Re: IBFS File No. SAT-MOD-20200417-00037; Call Signs: S2983 and S3018

Space Exploration Holdings, LLC (SpaceX) has asked the Commission to authorize a wholesale reconfiguration of the company's non-geostationary satellite orbit (NGSO) fixed-satellite service (FSS) system.¹ It now requests permission to lower the altitude of 2,824 of the company's operational and replenishment satellites by as much as 785 kilometers and double the number of orbital planes.² SpaceX's proposal would result in a much denser web of satellites orbiting than ever before contemplated and, with it, a concomitant increase in the unwanted power SpaceX's NGSO system transmitting into co-channel Ku-Band direct broadcast satellite service (DBS) receivers that tens of millions of American consumers depend upon for news, entertainment, and information. Domestic and international rules require SpaceX to demonstrate that its power will not exceed what a standard DBS reference antenna can tolerate.³ SpaceX has failed to make a facially sufficient showing of compliance, and SpaceX's failure requires dismissal of its application.

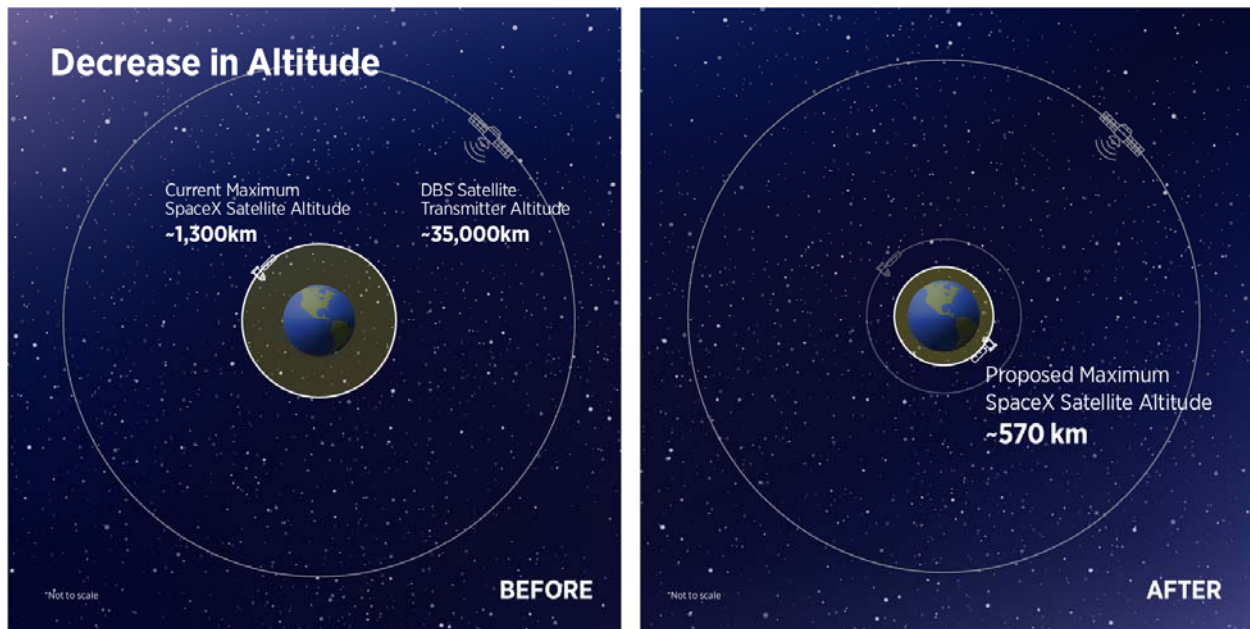
The simplified diagrams below depict how some of the latest proposed changes to the SpaceX system will affect DBS receivers on the ground. First, SpaceX proposes to drop its entire system (4,408 satellites) to substantially lower altitudes.¹²

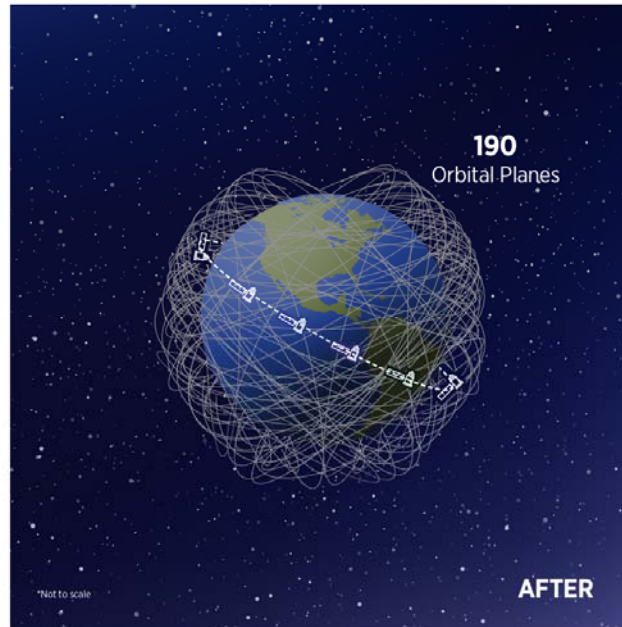
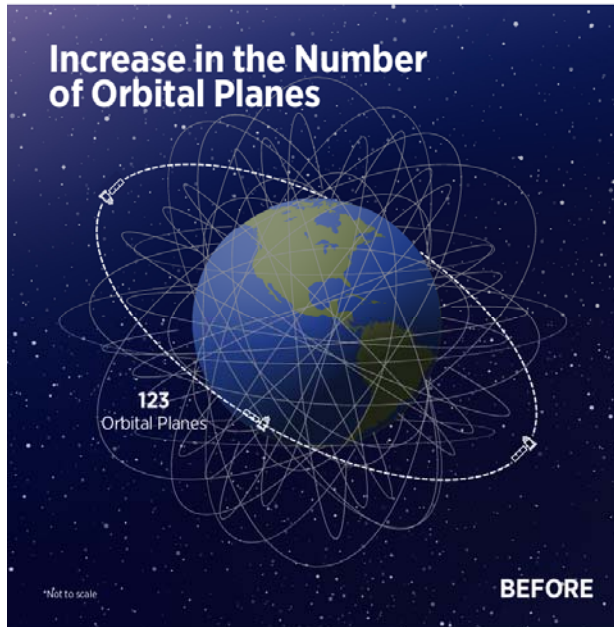
Second, SpaceX proposes to increase the number of orbital planes its system will use from the 83 the FCC originally authorized, beyond the 123 currently authorized, to a new record of 190 orbital planes.¹³

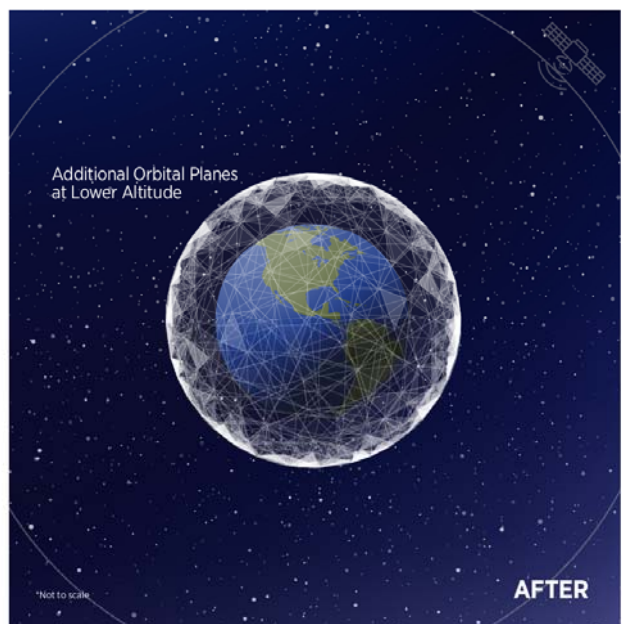
Taken together, these two variations have the effect of “tightening the net” of satellites encircling the Earth. As shown below, these changes create a sort of “Hobbesian” sphere in which satellite density increases as altitude is reduced and the number of orbital planes are increased.

The effect of these changes is to position more SpaceX satellites in between the distant GSO satellites DBS operators, such as those DISH Network relies on to deliver services, and the equipment that their customers use to receive these signals in the band.
